<b>Terex Utilities</b>	
<b>SAFETY NOTICE</b>	<b>SN732</b>
<b>NHTSA Recall No.</b>	<b>24V-740</b>

**MODELS AFFECTED:** TM, TL80, TL80/112, & TL100 Aerial Devices

**SUBJECT:** Jib Extension Cylinder Rod Weld

Figure 1. Load Line Hook Secured to Anchor on Main Jib Boom

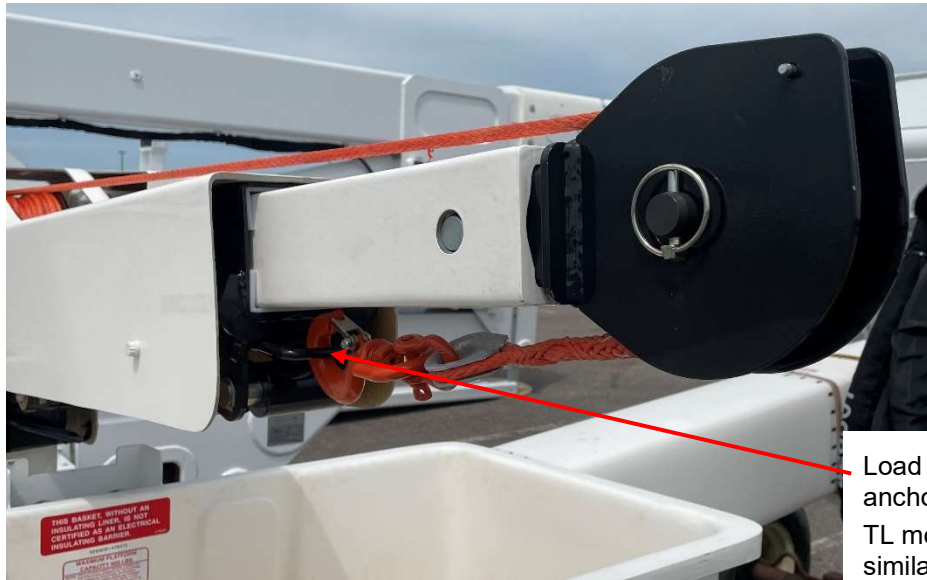
1. Always follow the inspection and maintenance requirements as specified in the manuals.
2. Ensure the jib extend hydraulic cylinder is at or above horizontal when loaded.
3. Secure the load line hook when stowing the machine as shown in Figure 1 below.

Load line secured to anchor on jib.  
TL model shown, TM similar.
